Access Compliance Report

Public Rights-of-Way

(Curb Ramps)

Intersection ID: 13667	Main Street: E_7TH_ST	Cross Street: HAWTHORNE_LN	Location: W
ADA ID: 921AF9A9A23A	Ramp Type: Perp	Initial Pass/Fail: Fail	Overall Compliance: No
Severity Score: 13.75			
Codes/Mitigation Info/Possible Solution		Field Measurements/Component Compliance

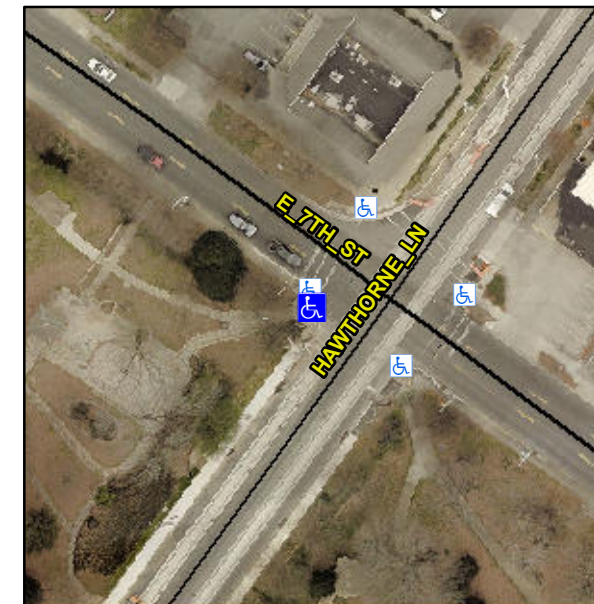
R304.2.2, R304.5.3

Compliance	Description	Data	Compliance	Description	Data
N/A	Ramp Length (in)	68.0	No	Ramp Slope (%)	8.8
Yes	Ramp Width (in)	48.0	No	Ramp XSlope (%)	2.4
N/A	Flare Type LT	N/A	N/A	Flare Type RT	N/A
N/A	Flare Slope LT (%)	N/A	N/A	Flare Slope RT (%)	N/A
N/A	Flare Traversable LT?	N/A	N/A	Flare Traversable RT?	N/A
N/A	Landing Length (in)	N/A	N/A	DWS Provided?	N/A
N/A	Landing Width (in)	N/A	N/A	DWS Contrast?	N/A
N/A	Landing Slope (%)	N/A	N/A	DWS Length (in)	N/A
N/A	Landing X Slope (%)	N/A	N/A	DWS Full Width?	N/A
N/A	Landing Curb? (Y/N)	N/A	N/A	DWS Offset (in)	N/A
N/A	Shared Landing?	N/A			
N/A	Gutter Ponding?	N/A	N/A	Gutter Slope (%)	N/A
N/A	Gutter Lip Ht (in)	N/A	N/A	Gutter X Slope (%)	N/A
N/A	Painted X Walk1?	Yes	N/A	Painted X Walk2?	N/A
	X Walk 1 Direction	To SE		X Walk 2 Direction	N/A
N/A	X Walk 1 Width (in)	109.0	N/A	X Walk 2 Width (in)	N/A
	X Walk 1 Slope (%)	2.6		X Walk 2 Slope (%)	N/A
	X Walk 1 X Slope (%)	1.6		X Walk 2 X Slope (%)	N/A

Remove & Replace Entire Ramp.
